MEMORANDUM

TO: Ginny Rowen
CC: James Gulson, Oxford Capital Partners
Bob Woodruff, W H Gordon and Associates
Antonio J. Calabrese, Cooley Godward Kronish LLP
FROM: Ben I. Wales
DATE: September 9, 2009
RE: ZMAP 2007-0004 National Conference Center

Further to our recent meeting, this letter provides confirmation of responses to the latest referral comments provided for the above referenced rezoning application. Each comment is summarized (noted in italics) and followed by our response.

Figure 1B
Existing (2008) Peak Hour Levels of Service

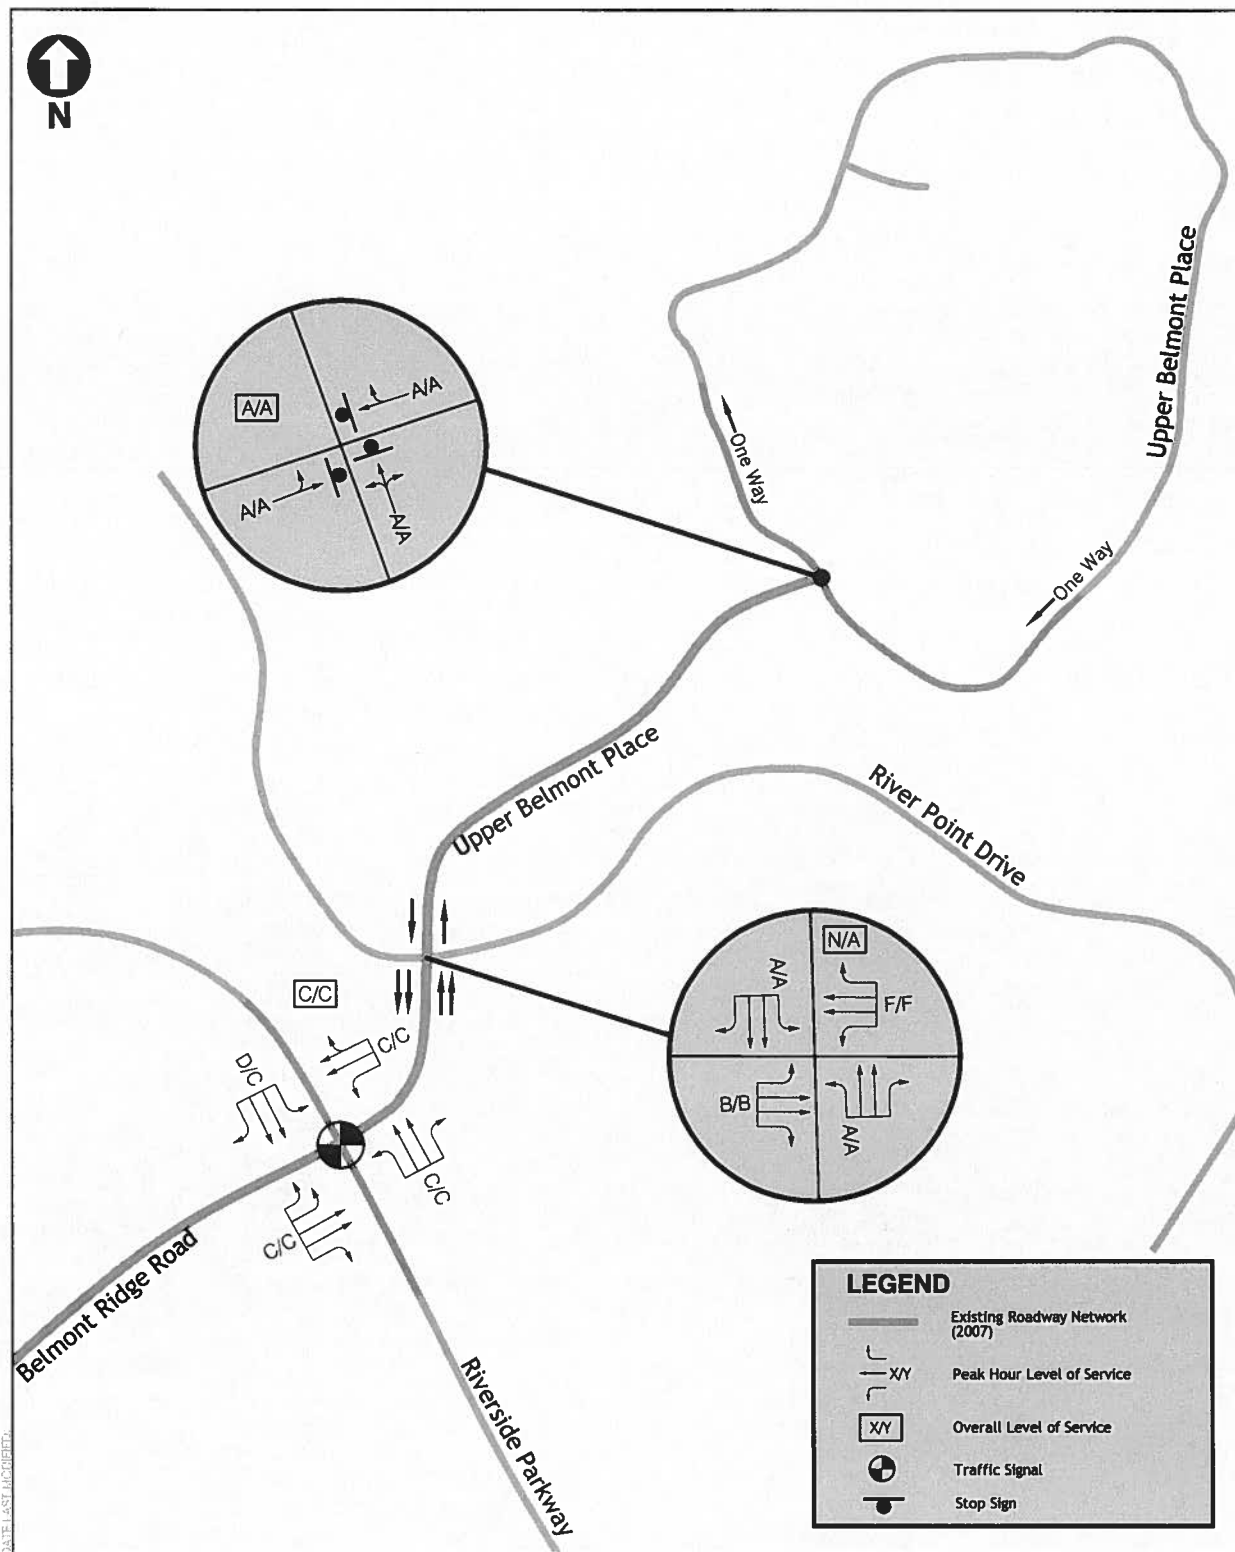
Comment 1: Existing lane configuration and traffic control at the Upper Belmont Place/Riverpoint Drive intersection are not accurately depicted (Figure 1B). The same inaccurate lane configuration is also depicted for future conditions with one and two entrances to the proposed development (Figures 2B and 3B, respectively).
